ADDENDUM NO. 2

ATLANTA-FULTON COUNTY WATER TREATMENT PLANT BULK HYPOCHLORITE SYSTEM AND FILTER/PLATE SETTLER IMPROVEMENTS

ATLANTA-FULTON COUNTY WATER RESOURCES COMMISSION JOHNS CREEK, GEORGIA

June 15, 2010

CHEMICAL BUILDING
RAW WATER CHLORINE FEED

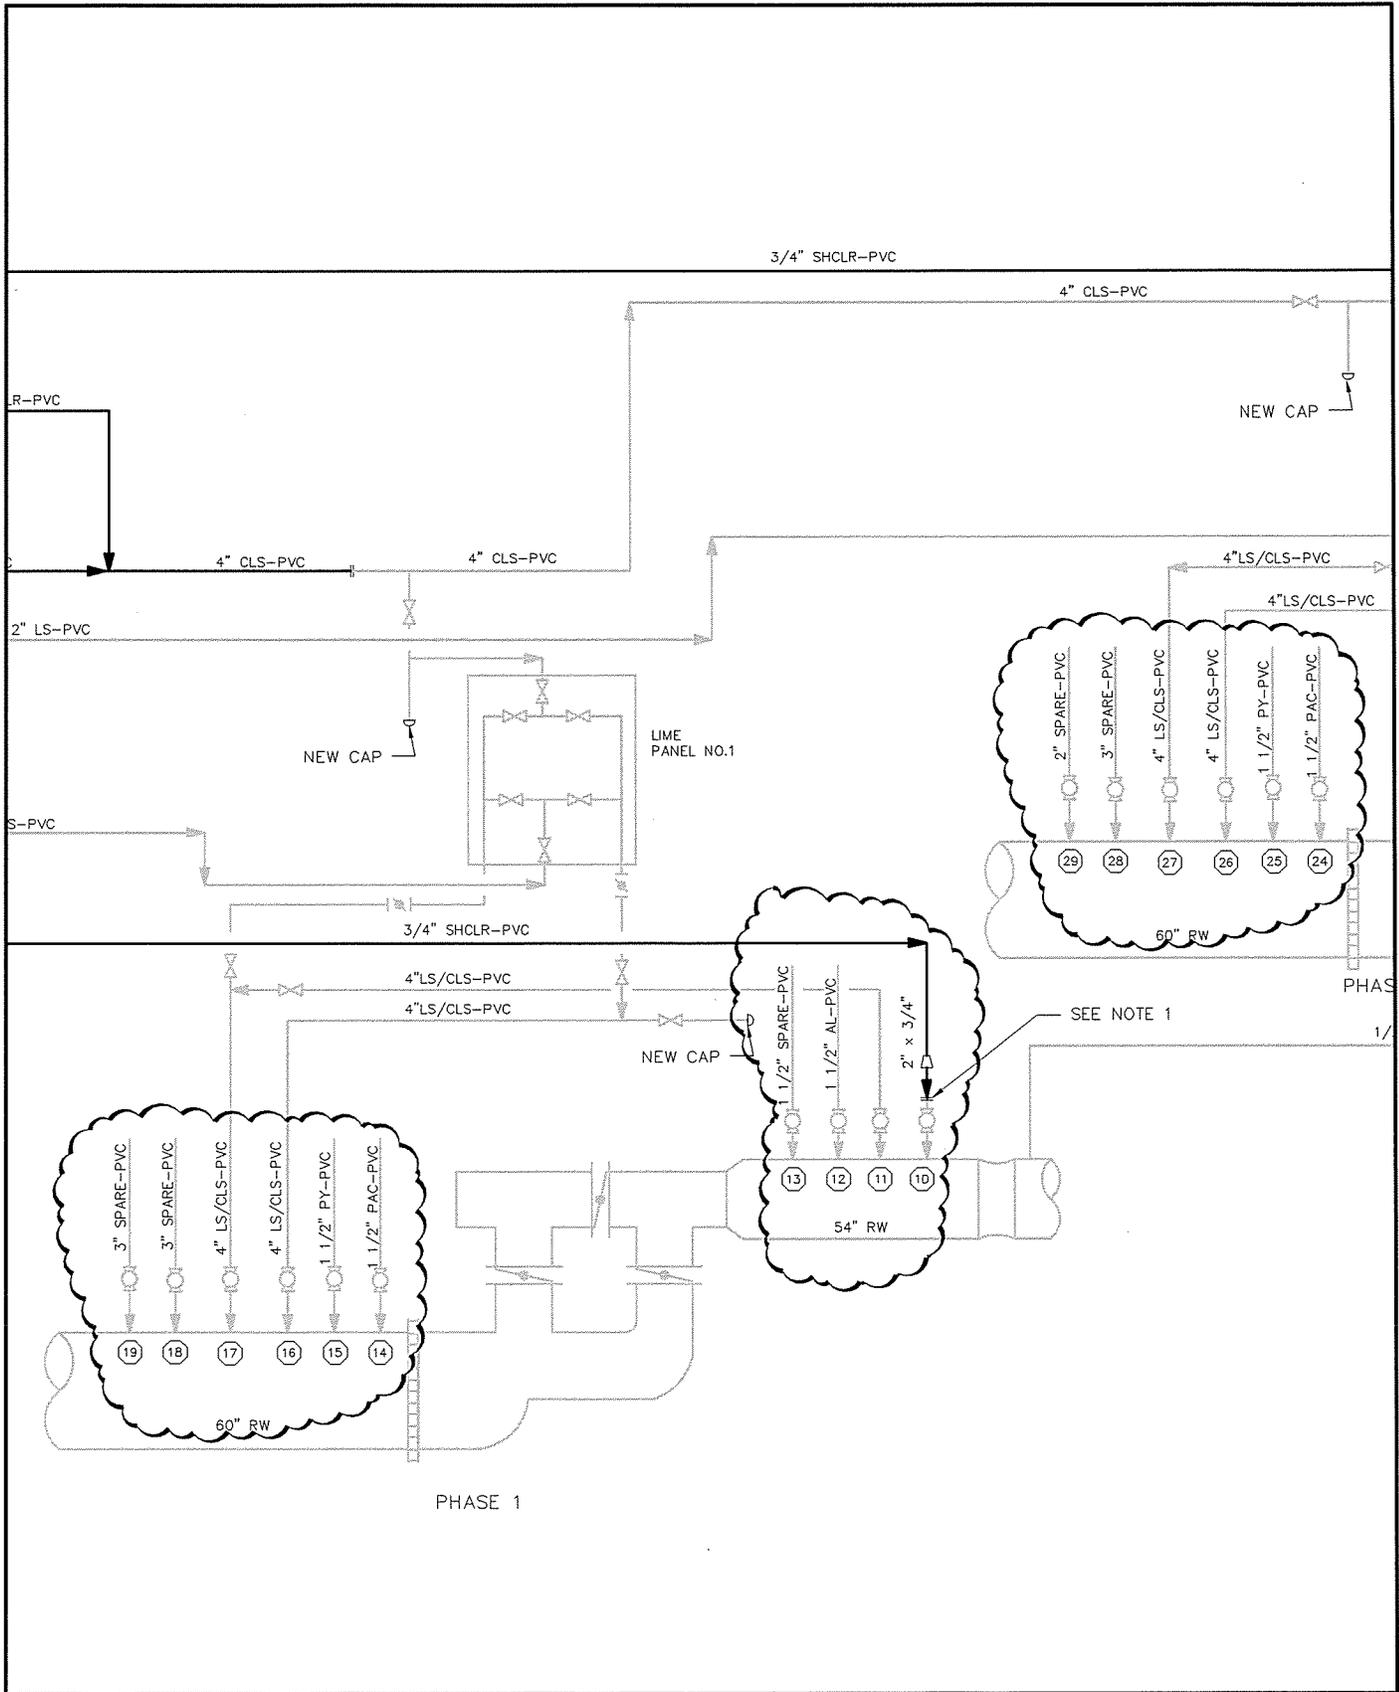
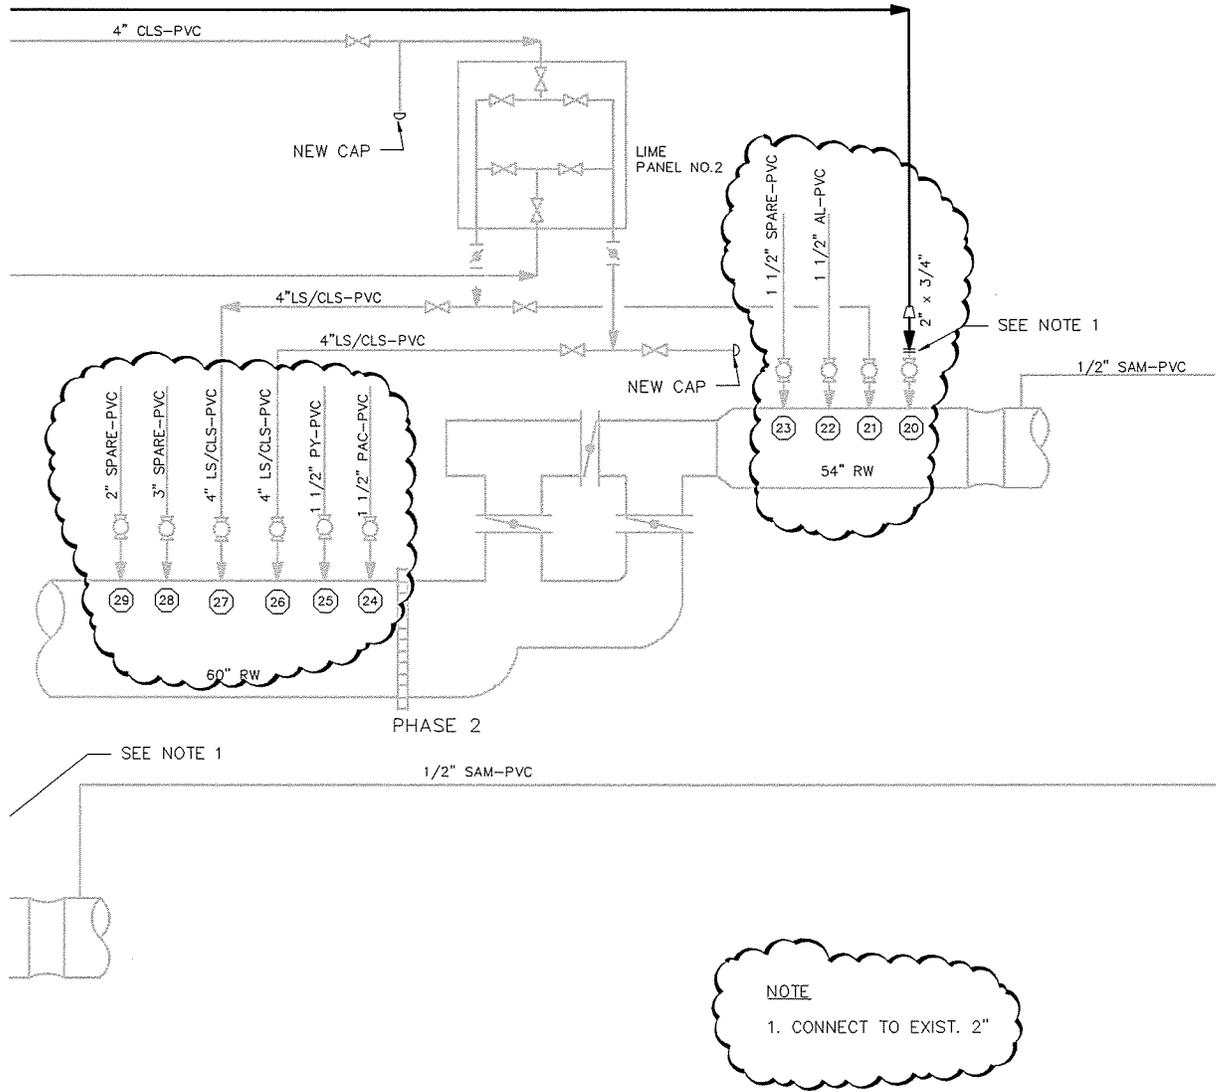
11. Sheets I-200-04, -05 and -06, delete pulsation dampeners and associated isolation valves and pipe tees.
12. Revise Sheet I-200-08 in accordance with Sketches I-1 and I-2 included with this addendum.
13. Sheet D-DT-01, delete Details 2202 and 2208 in their entirety.
